## **Appendix A: Draft EIR Comment Letters**

## San Francisco Bay Regional Water Quality Control Board

Subject: Comments on Draft Environmental Impact Report, Spieker Senior Continuing Care Community Project, Contra Costa County (State Clearinghouse No. 2021070517)

Before - Current GIS graphic generated view end of Kinross Drive

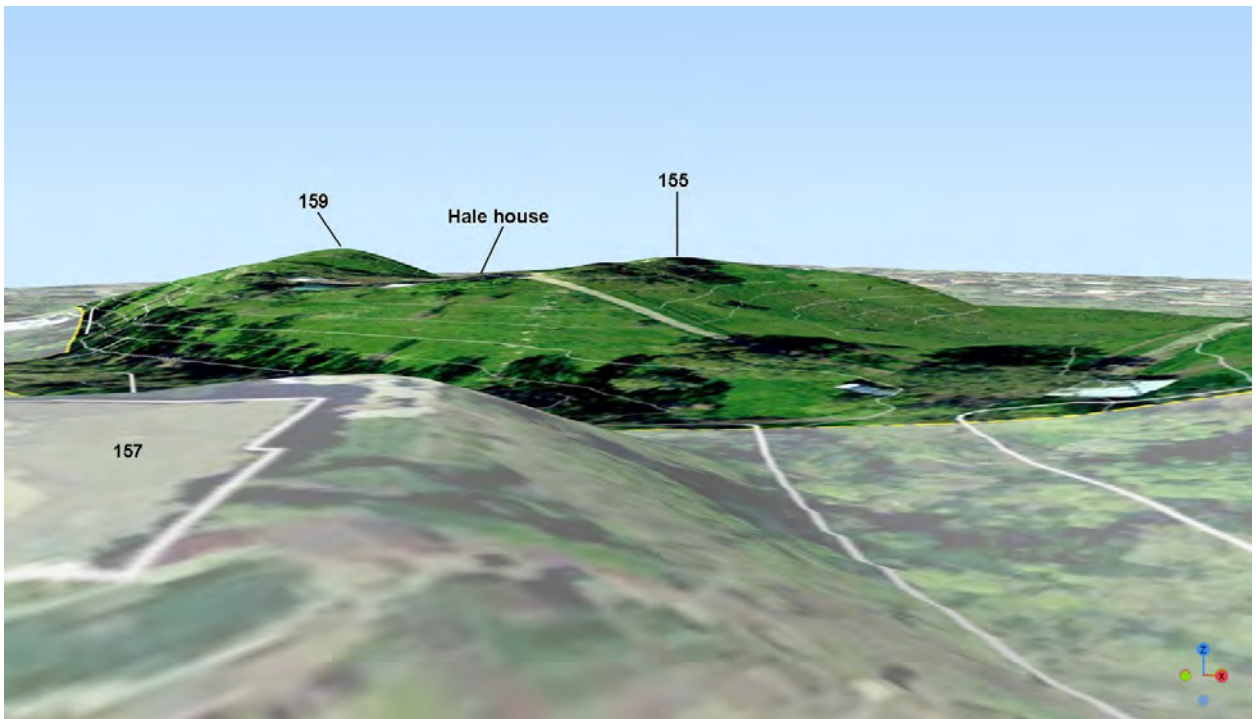
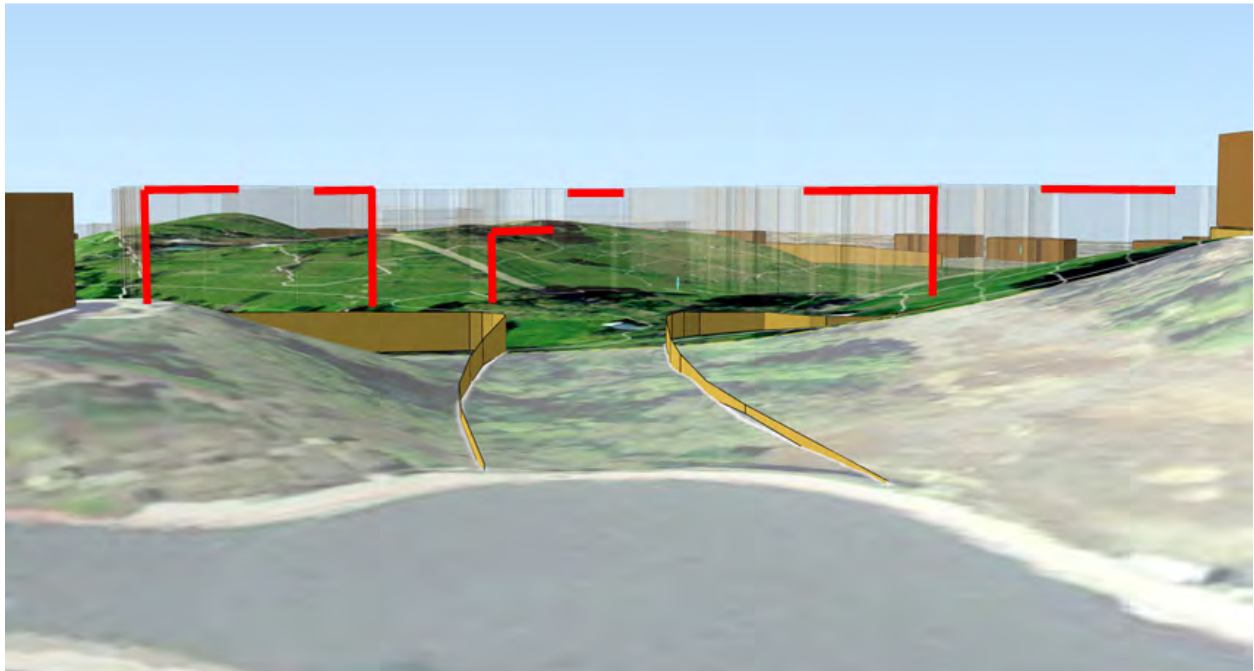
- DEIR Photo views from Kinross Dr. are questionable and proper visuals must be re-requested for the DEIR to be informative. The vegetation is imaginative yet not stated as so. To show trees growing over the 49 foot height of the building in DEIR Photo Simulation Figure 3.1-2 is unrealistic, just as are the large tree massings shown along the roadway. In fact, plans call for retaining walls along the roadway entrance and the area of the phantom trees and those walls are not indicated in the photo simulations. It is doubtful that trees shown in the photo simulations will actually grow or be retained under the conditions proposed by the project.

**These photos and photo simulations must be re-requested, asking for more accurate depictions of the current and proposed scenarios. It is essential that decision makers understand clearly the visual impacts of this proposed project which is in actuality out of place with and jarringly impactful on its surroundings.**

### Inaccuracies in Photomontage View of Site from Kinross Drive in Figure 3.1-2 of DEIR

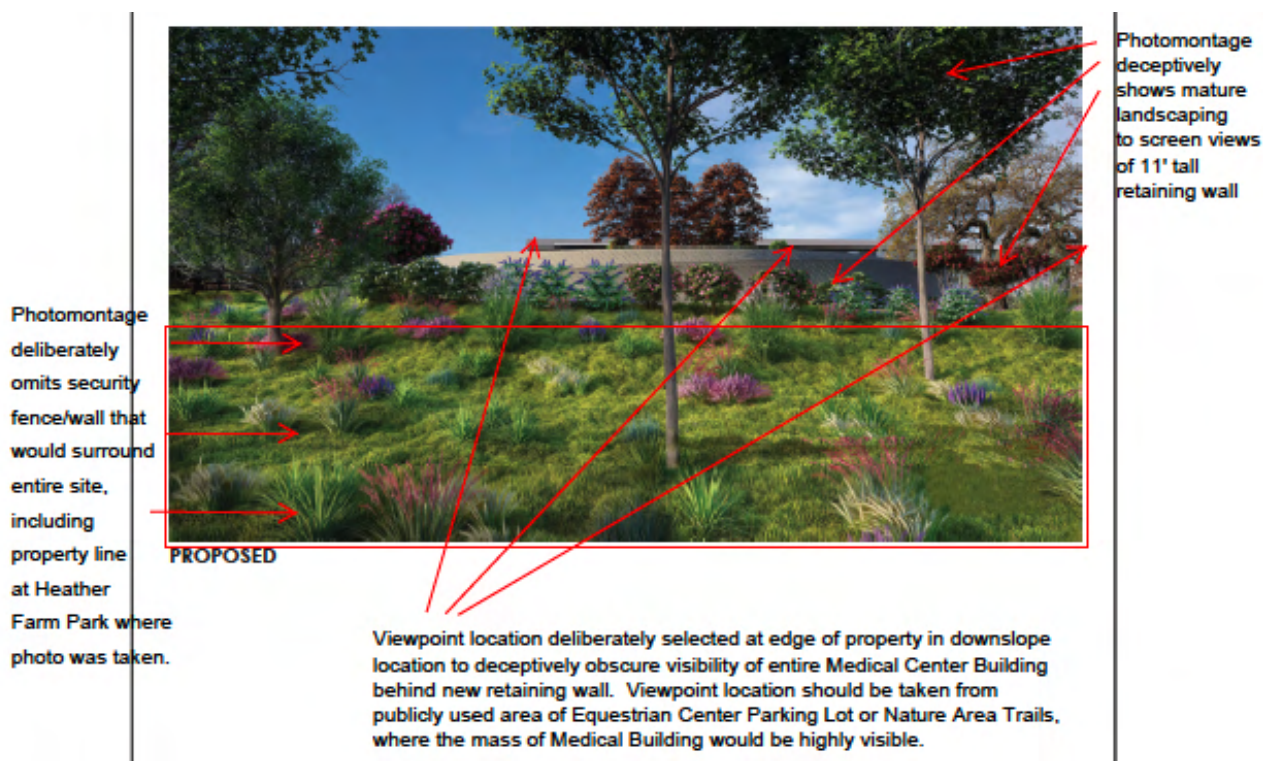
The photomontage depicted in Figure 3.1-2 shows views of the SHR site from Kinross Drive, but is grossly inaccurate as indicated in the markup of the photomontage below and must be redone for the Recirculated DEIR. Kinross Drive would be extended directly through the riparian woodland on the far side of the cul-de-sac in this view. The Main Building would be highly visible in views from Kinross Drive and Club View Terrace as most of the existing trees that currently screen or occupy the site would be removed. The roof peak of the Main Building would be at an elevation of about 180 feet, an estimated 30 feet higher than the elevation where this particular photograph was taken. The entrance to the building would be two stories, but the four stories that ring the structure would be visible behind the entrance area, forming a continuous horizon line not depicted in the photomontage. The Main Building would occupy most of this view, stretching out of view beyond the hillside at the right edge of the photograph and in line with the single-story residence on the west side of Club View Terrace on the left edge of the image, and higher than the existing tree canopy between these points, none of which is accurately depicted in the photomontage. The applicant's Preliminary Arborist Report, referenced in the DEIR, inaccurately assumes the valley oaks on the south (left) side of the entrance road off of Kinross Drive would be retained. But the trunks of these trees would be located just a few feet from the new retaining wall and roadway, and construction would so severely affect these trees that they most likely could not survive. Most of the existing trees along the Kinross Drive extension through this riparian corridor and on the site itself should therefore not be shown as being retained in the photosimulation because they would be removed and part of the proposed Project, and they currently inaccurately screen much of the new Main Building in views from this location and closer to the intersection with Club View Terrace.

New dense landscaping is also shown in this photomontage, which screens over 70 percent of the portions of the Main Building that would otherwise be visible. Landscape screening should not be shown in the corrected photomontages or should be shown to represent the progressive change over the next 20 or so years as landscaping matures, showing views of the site at one year after completion of construction and a second photomontage at five to 10 years after construction. A corrected photomontage for the view in Figure 3.1-2 should be prepared by an independent consultant who specializes in visual simulations, which accurately depict views of the site at Year 1 and Year 5 after construction, and included as part of the updated analysis in the Recirculated DEIR.

#### Inaccuracies in Photomontage View of Site from Heather Farm Park in Figure 3.1-3 of DEIR

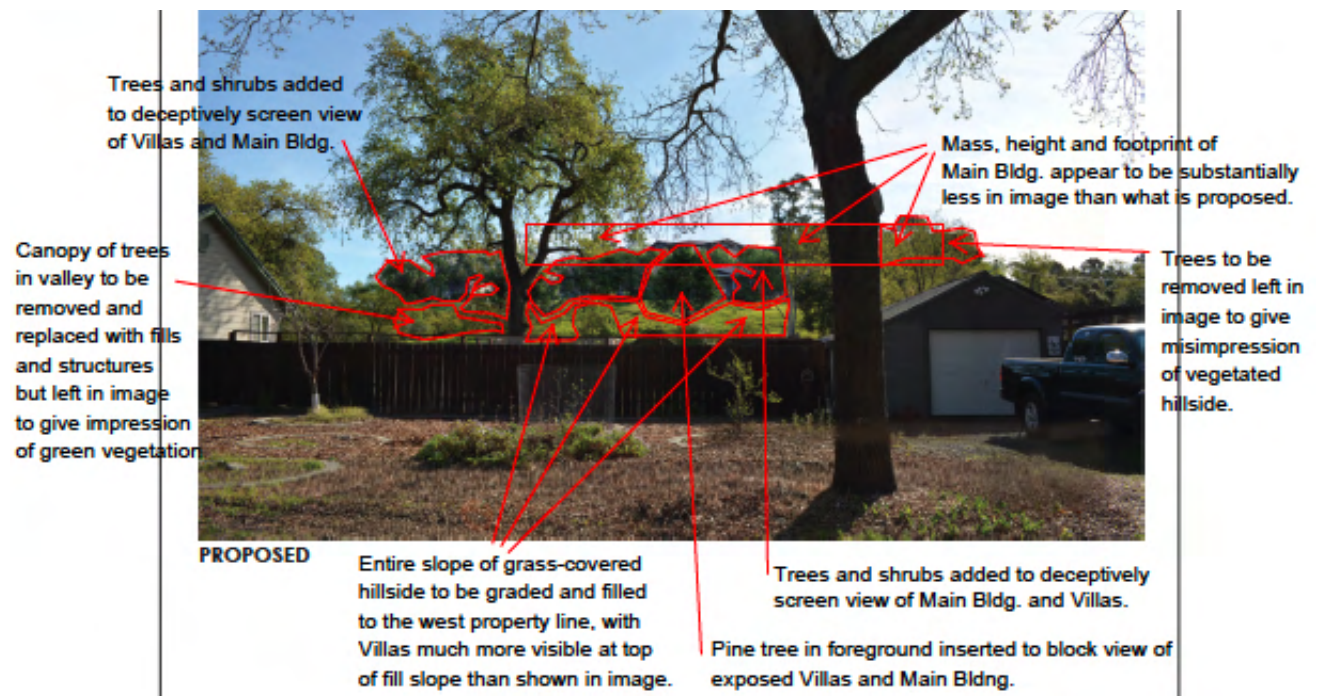
The photomontage depicted in Figure 3.1-3 shows views of the SHR site from the edge of the property above the Equestrian Center in Heather Farm Park, but this does not accurately represent the views of the SHR site from the adjacent parklands or North San Carlos Drive indicated in the markup of the photomontage below, and distorts the visibility of the enormous 85,000 SF Medical Center Building that would loom over the park. By selecting a photomontage location at the bottom of the hillside, the new 12 foot retaining wall would physically screen any view of the structure from that location. If a more realistic location had been used for the photomontage, one that park visitors actual use along North San Carlos, the parking lot to the Equestrian Center, or from the Nature Area, then the massiveness of the Medical Building structure would be revealed beyond the retaining wall or along the south side of North San Carlos Drive near the entrance to Seven Hills School. Under the proposed Project, a retaining wall would be installed within the tree canopy above the specimen oak and extend down the east (left) side of the tree, reaching a height of almost 12 feet in the foreground above the Equestrian Center. The Medical Center would surround the uphill side of the specimen tree, completely altering the existing undeveloped character of the SHR site. The entire ridgeline above the oak would be graded away to a depth of 13 feet or more, which would likely no longer be visible in views from Heather Farm Park given the extent of grading and height of the proposed Medical Center. Grading, retaining wall construction and changes in surface hydrology would all pose risks to the long-term health of the specimen oak that currently dominates views from Heather Farm Park, which could lead to its eventual decline and death, none of which was disclosed in the DEIR.

In addition, no information was included in the DEIR on the design and height of the security fencing or wall that would presumably be installed round the entire SHR site, including along the property line where it borders Heather Farm Park. It is unlikely that the proposed Project would not replace the existing three strand barbed wire fence that remains in the vicinity of the photograph in Figure 3.1-3 and

Landscape screening should not be shown in the corrected photomontages or should be shown to represent the progressive change over the next 20 or so years as landscaping matures. A corrected photomontage for the view in Figure 3.1-3 should be prepared by an independent consultant who specializes in visual simulations, which accurately depict views of the site at Year 1 and Year 5 after construction, and included as part of the updated analysis in the Recirculated DEIR.

**Map of Central Perennial Drainage - showing incursion into minimum 50-foot setback and direct impact to riparian habitat that could be avoided by relocating proposed bridge outside of tree canopy**

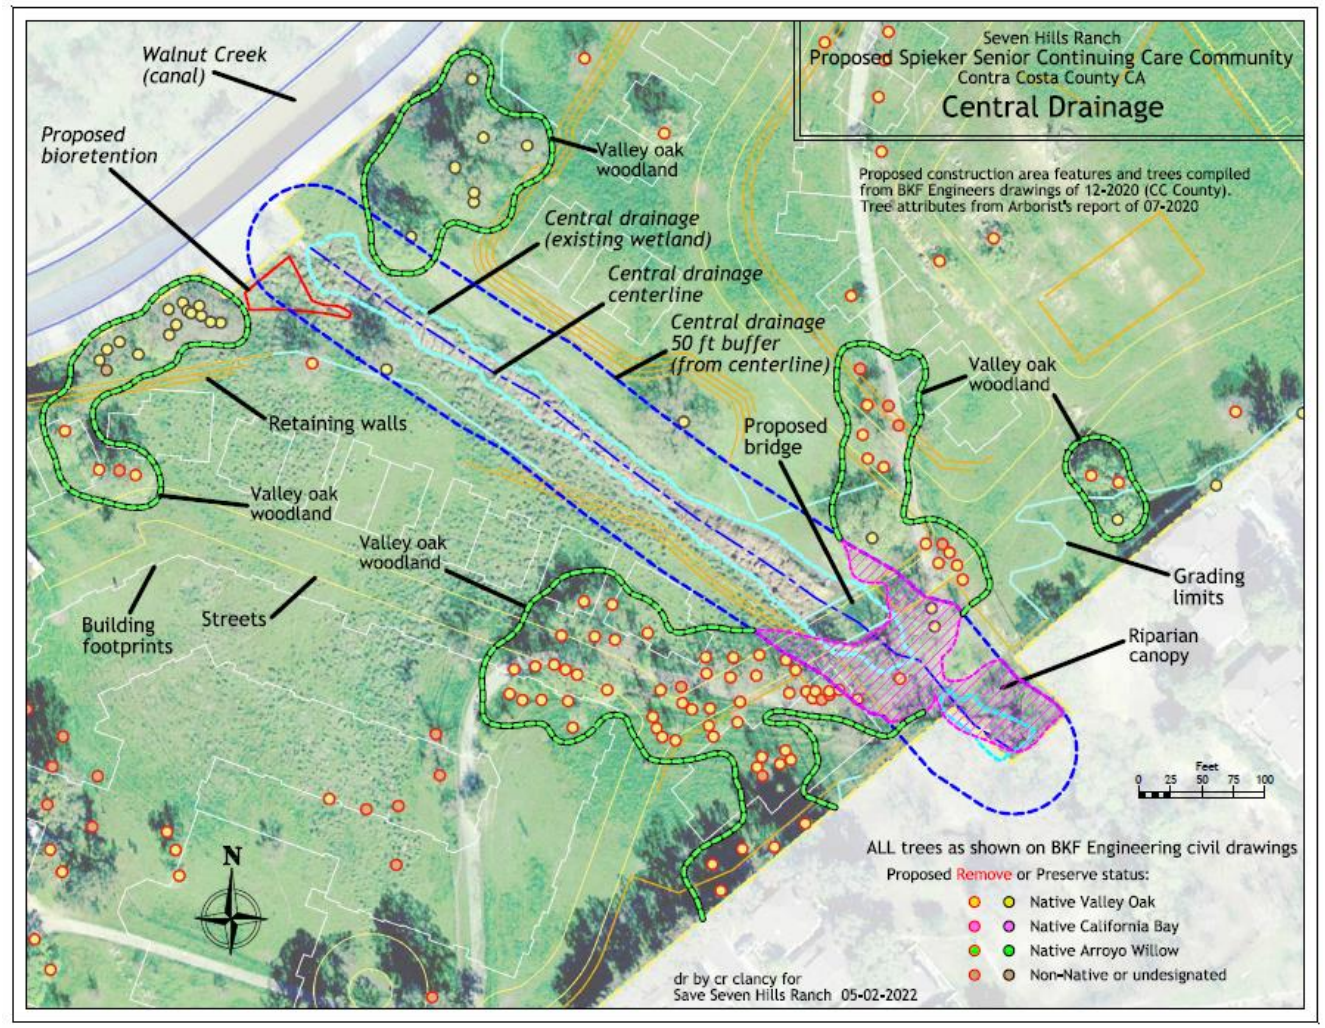
County ordinance and General Plan policies call for a minimum 50 foot setback from creeks, among other protections not addressed in the Biological Resources section of the DEIR. Contrary to the assertion on page 86 of the DEIR which claims that “the project has been designed to incorporate a 50-foot setback from the centerline of the central drainage and proposes restoration and enhancement of wetland and riparian habitat within this preserved corridor” this minimum setback distance is not met as indicated in Figure 2 of the HTH review and shown in greater detail in the Central Perennial Drainage Map below. As clearly shown in the Central Perennial Drainage Map below, proposed retaining walls of 20 or more feet in height would extend within this 50-foot minimum setback for a distance of over 300 feet on the south side of the drainage and a large bioretention basin is proposed at the downstream end of this minimum setback distance. The bioretention basin qualifies as a “structure” as it is a constructed basin that would require future on-going maintenance, limits what type of vegetation can become established in this basin. Its location near the confluence of the central perennial drainage with Walnut Creek would also restrict opportunities for native plantings and possible future enhancement of the Walnut Creek channel, as discussed further below. As noted above under the comments on Loss of Protected Trees and Woodland Habitat, the proposed Project would affect far more of the sensitive riparian habitat than is marked in Figure 2 of the HTH review along the proposed main entrance off of Kinross Drive and summarized in the discussions under Impacts BIO-2 and Impact BIO-3 in the DEIR. This additional riparian and woodland habitat affected by the proposed Project that was not disclosed in the DEIR is clearly visible in the Central Perennial Drainage Map and Southern Perennial Drainage Map

Proposed mitigation should be achieved by 1) further avoidance of direct impacts to riparian and wetland habitat along the central drainage by relocating the proposed bridge location to avoid loss of riparian tree cover, as discussed above under comments on Sensitive Natural Communities, and 2) by providing an adequate setback from the southern perennial drainage and enhancing this feature in its existing or relocated alignment, providing a minimum 50 foot setback distance in accordance with County minimum setback distances and enhancing the on-site segment from the Kinross Drive extension to the Homestead Avenue undercrossing. Structures should be restricted within the required setback zones and the limits of grading and other project-related improvements such as biofiltration basins located outside the central perennial drainage and southern perennial drainages, as these would compromise the future enhanced value of these features and their function as appropriate locations to mitigate for the unavoidable impacts associated with the proposed Kinross Drive extension and

Figure 5 Proposed Bridge over the Central Drainage Wetlands

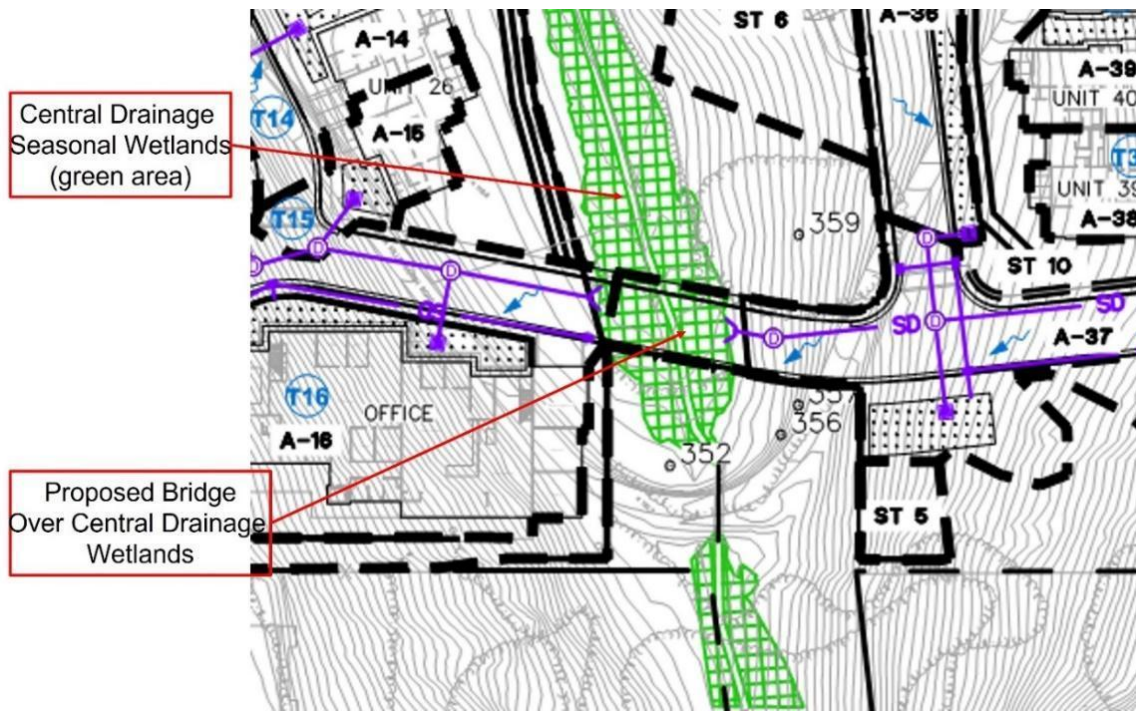
- The protective fencing must be sturdy and metallic.
- Figure 4 is an example of such a sturdy, metallic fence that must be extended to ground level for the proposed development to protect the Central Drainage and Walnut Creek. Does the developer intend to use a sturdy, metallic fence?
- What height will the fencing be and how far from the seasonal wetland boundary will it be installed?
- How does the developer intend to construct the bridge over the Central Drainage without damaging the seasonal wetlands (Figure 5)?
- The impact to the Central Drainage wetlands and Walnut Creek won't be known until the developer discloses its fencing plans and bridge construction plans.
- The fencing and bridge construction plans must be included in the DEIR and reissued.

Figure 1 Utility Plan C5.0

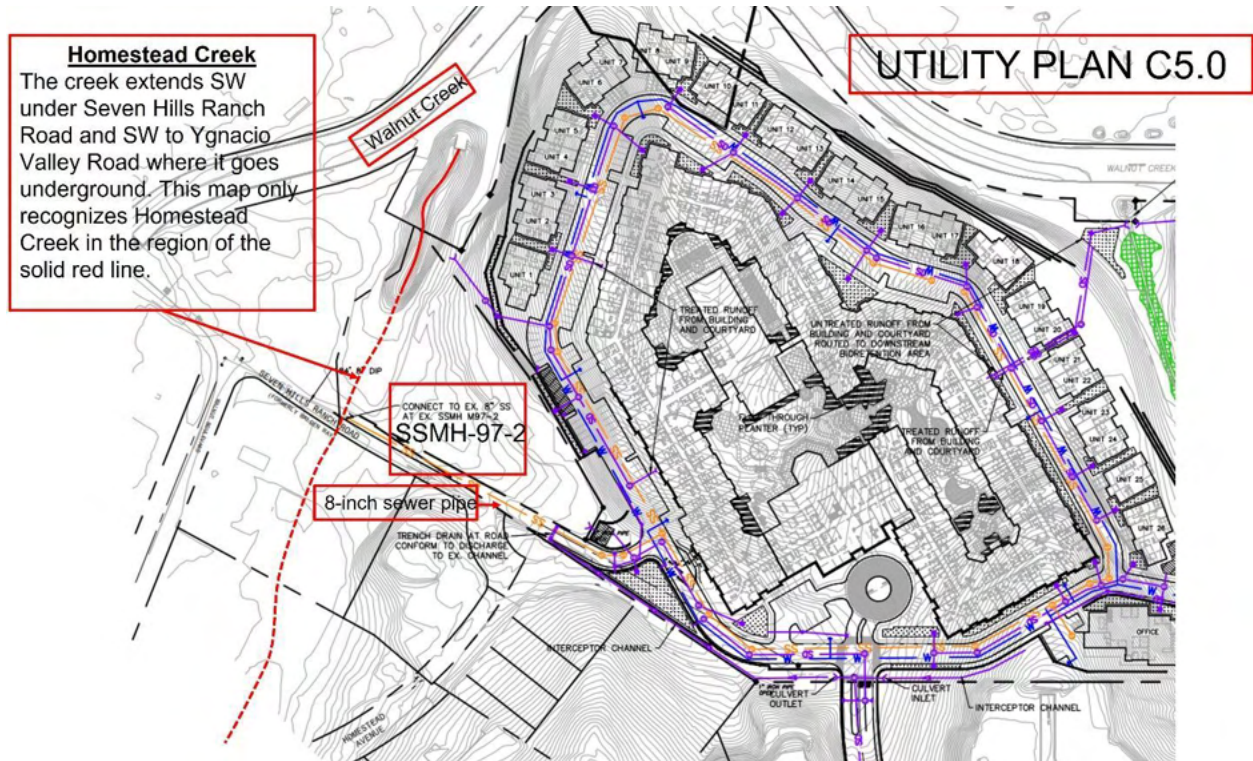
There may be a relatively high environmental risk from overflow at the proposed connection location of the sanitary sewer pipe carrying project flow west from the site to the manhole designated SSMH 97-2 on Drawing C5.0, Utility Plan because this manhole is only two feet deep and it is located immediately above a natural creek flowing into Walnut Creek.

Figure 3 The culvert under Seven Hills ranch Road with the approximate positions of the 8" sewage pipe and Manhole SSMH-97-2. Note disrepair over culvert.

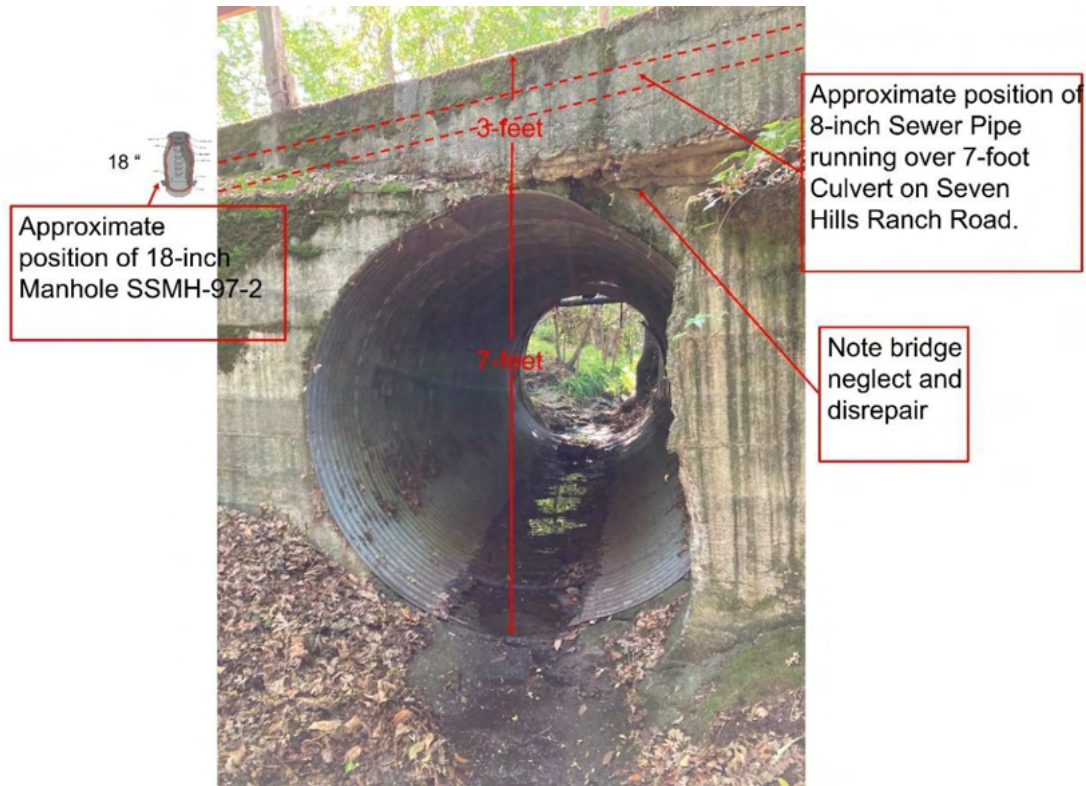
97-2 on Drawing C5.0, Utility Plan because this manhole is only two feet deep and it is located immediately above a natural creek flowing into Walnut Creek.” Mr. Cain’s letter notes that, because the system is failing, there is a potential for pressure build-up in the sewage line which could result in raw sewage overtopping the manhole cover and being released into Homestead Creek and, ultimately, into Walnut Creek.
